**FEMA Levee Certification
Ventura County, California**

**Calleguas Creek Levee (CC-3)
Pleasant Valley Road to Highway 101**

**Evaluation Report
February 27, 2009**

- Exhibit 1 – Field Investigation Report
- Exhibit 2 – Preliminary Evaluation of Levee System Profiles
- Exhibit 3 – As-Built Plans Status List
- Exhibit 4 – Responses to Comments on Draft Evaluation Report

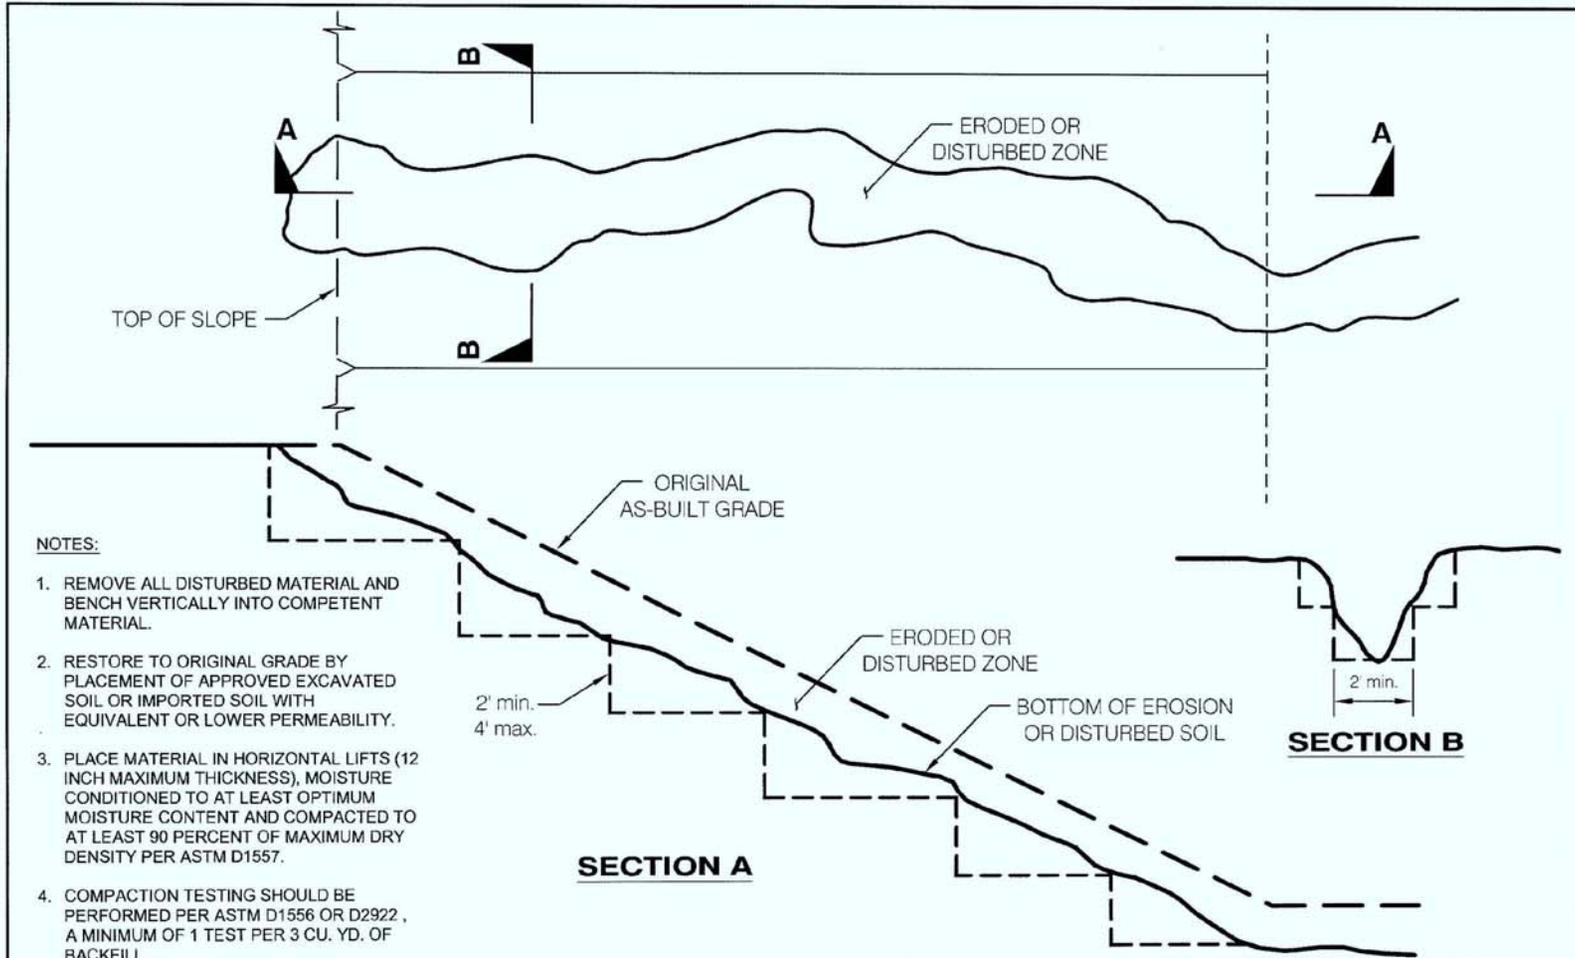
<p>4. Can Tetra Tech provide specs for compaction and grading requirements? Discuss major and minor repair examples.</p>	<p>Compaction requirements are detailed on the attached Figures 1 and 2. Major repair examples include any erosion feature that is deeper than 1 foot or that is greater than 2 feet wide. Major and minor animal burrows are discussed in item 1.</p>
<p>5. Can in-kind materials be used for backfill?</p>	<p>In-kind backfill would be materials free of organic or deleterious debris that has similar or lower permeability than the levee material. These materials could consist of excavated soil, imported soil, concrete, or slurry, and shall be evaluated by the testing and materials lab.</p>
<p>6. Discuss documentation/inspection requirements for verification of grading.</p>	<p>The requirements for verification of grading are discussed above.</p>

1. REMOVE ALL DISTURBED MATERIAL AND BENCH VERTICALLY INTO COMPETENT MATERIAL.
2. RESTORE TO ORIGINAL GRADE BY PLACEMENT OF APPROVED EXCAVATED SOIL OR IMPORTED SOIL WITH EQUIVALENT OR LOWER PERMEABILITY.
3. PLACE MATERIAL IN HORIZONTAL LIFTS (12 INCH MAXIMUM THICKNESS), MOISTURE CONDITIONED TO AT LEAST OPTIMUM MOISTURE CONTENT AND COMPACTED TO AT LEAST 90 PERCENT OF MAXIMUM DRY DENSITY PER ASTM D1557.
4. COMPACTION TESTING SHOULD BE PERFORMED PER ASTM D1556 OR D2922, A MINIMUM OF 1 TEST PER 3 CU. YD. OF BACKFILL.

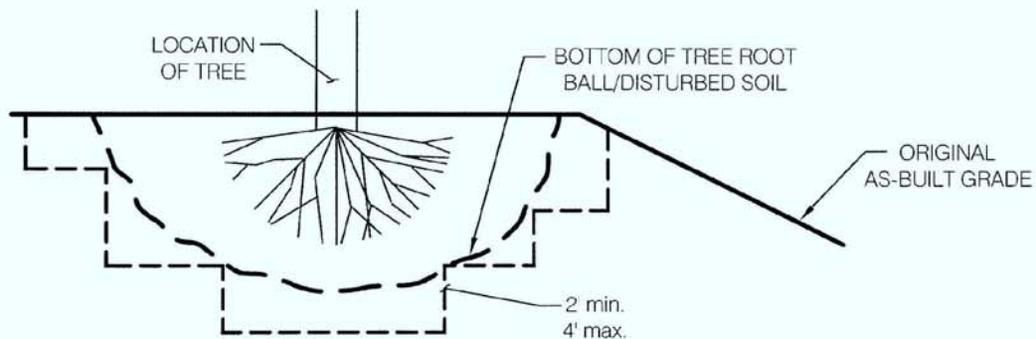
<p>2. Please describe methods for vegetation and rootball removal.</p>	<p>4" DIAMETER TRUNK OR GREATER: Cut the woody vegetation approximately two (2) feet above ground level leaving a prominent stump for use in the rootball extraction process. Remove the stump and rootball by pulling or extracting with a backhoe or similar equipment. Clean the rootball cavity of all loose soil and remaining root system (roots greater than 1/2" diameter). Prepare the cavity by excavating per FIGURE 2. Backfill with excavated soil or imported soil with equivalent or lower permeability. Place material in horizontal lifts no greater than twelve (12) inches. Moisture conditioned to at least optimum moisture content and compacted to at least ninety (90) percent of the maximum dry density of the fill soil per ASTM D1557. Compaction typically requires the use of manually operated compaction equipment or compaction attachment to a backhoe. Compaction testing should be performed per ASTM D1556 or D2922. A minimum of one (1) test per three (3) cubic yards of backfill.</p> <p>2"-4" DIAMETER TRUNK: Cut the woody vegetation stump flush with the ground. Treat the stump with a protective coating similar to polyurethane to prolong the decay process.</p>

VCWPD O&M QUESTION	TETRA TECH/AMEC RESPONSE
	<p>2" DIAMETER TRUNK OR LESS: Cut the woody vegetation to twelve (12) inches of height above the ground level.</p> <p>For all vegetation removal under 4" trunk diameter, no documentation is necessary. For larger rootball removal in which excavation and compaction is required, documentation of the impacted material shall be conducted by a certified testing and materials lab that the District is familiar with. The documentation shall include a report provided by the testing and materials lab. AMEC will periodically observe these locations and will require a copy of the report for documentation and review.</p>
<p>3. Where is 15' buffer from toe measured from (buried portion or at ground level)?</p>	<p>The fifteen (15) foot vegetation line is measured from the visual toe of slope to the center line of the trunk (tree), the closest trunk to the toe (multiple trunk trees/plants) or the stock/stem protruding through the soil (large plant connected to a root system)</p>
